UNITED STATES PATENT AND TRADEMARK OFFICE

APPLICATION NO.	FILING DATE	FIRST NAMED INVENTOR	ATTORNEY DOCKET NO.	CONFIRMATION NO.
09/828,470	04/06/2001	Richard W. Layne	41914.551 / P0031752.01	6760
46333	7590	07/20/2009		
Medtronic Attn: Noreen C. Johnson, IP Legal Department 2600 Sofamor Danek Drive Memphis, TN 38132			EXAMINER NGUYEN, CAMTU TRAN	
			ART UNIT 3772	PAPER NUMBER
			MAIL DATE 07/20/2009	DELIVERY MODE PAPER

DETAILED ACTION

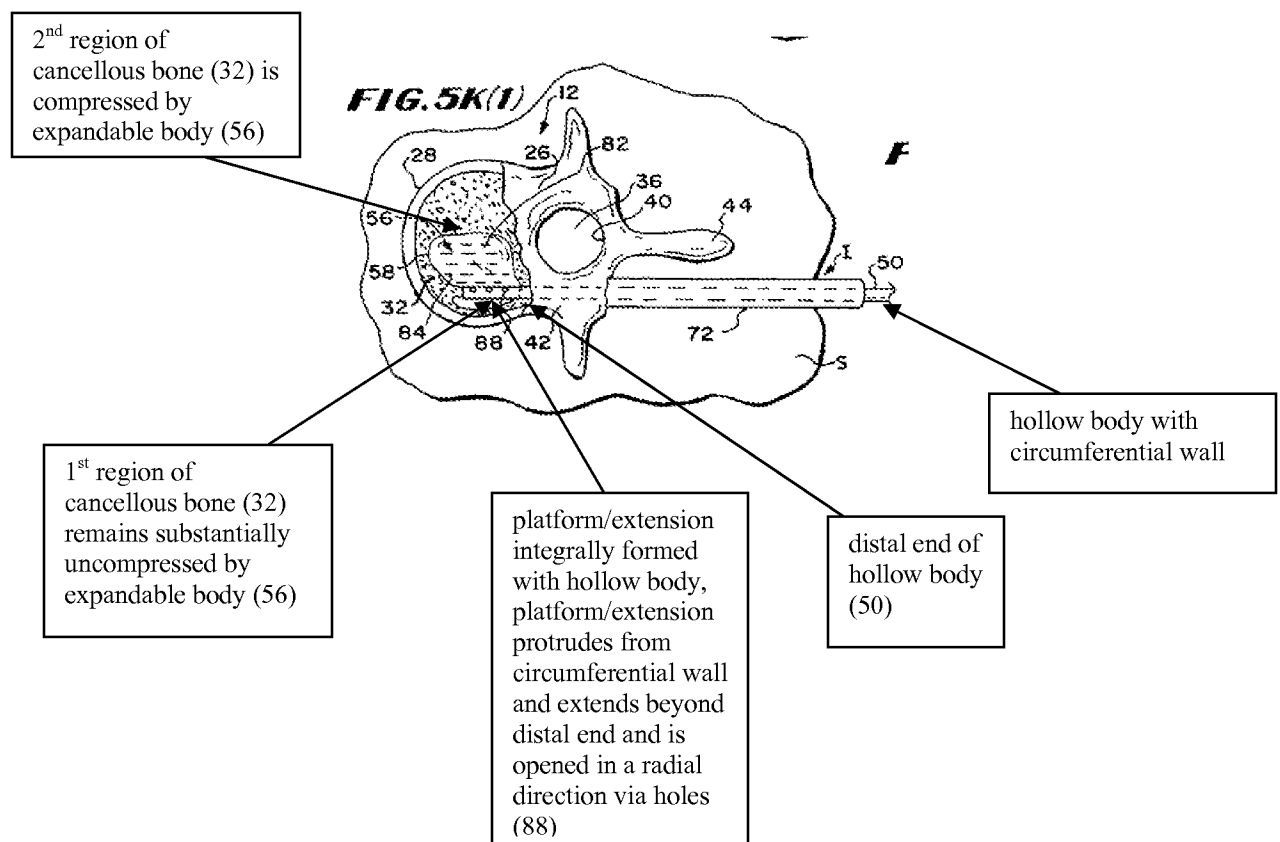
could be formed integrally with the hollow member (210), thus, for purposes of broad interpretation of the latter disclosure, it is reasonable for one skilled in the art to interpret the Reiley's Figure 5k(1) is consistent with applicant's specification. Furthermore, applicant's Figure 2, tool (200) comprising a distal end (250), an extension/platform (220) protrudes from tool's (200) wall and beyond the distal end (250). Applicant's Figure 2 illustrates the distal end (250) is closer to the tool's (200) proximal end than the extension/platform (220). See illustration below.

Figure 5K(1) illustrates the catheter (50) introduced into the interior volume (30) occupied in the cancellous bone (32) and the expandable body (56) expanding on one side of the distal end of the catheter (50).

Figure 5K(1) illustrates the platform/extension induce the expandable body (56) from expanding in more than one direction and expanding from the distal end towards the platform/extension. Figure 7 illustrates the injector tip (90) occupying in cavity (84) while the expandable body (56) collapses and the injector tip (90) injects filler material into the cavity (84).

With regards to the 1st step in claim 1 reciting the **platform that is open in a radial direction and has a side surface facing in the radial direction**, Figure 5K(1) illustrates the platform is open in a radial direction and that it has a side surface facing in the radial direction via holes (88).

With regards to claim 24, Figure 5K(l) of the Reiley et al illustrates the extension/platform (see illustration above) extends beyond the catheter tube (50) from only a circumferential portion of the catheter tube's (50) circumferential wall, particularly when the extension/platform extends at central point of hole (88), thereby, rendering the extension/platform extending from only a circumferential portion of the catheter tube's (50) circumferential wall and not the entire circumferential wall.

Clearly, the illustration of Reiley et al's Figure 5K(l) interpreted above discloses applicant's invention.
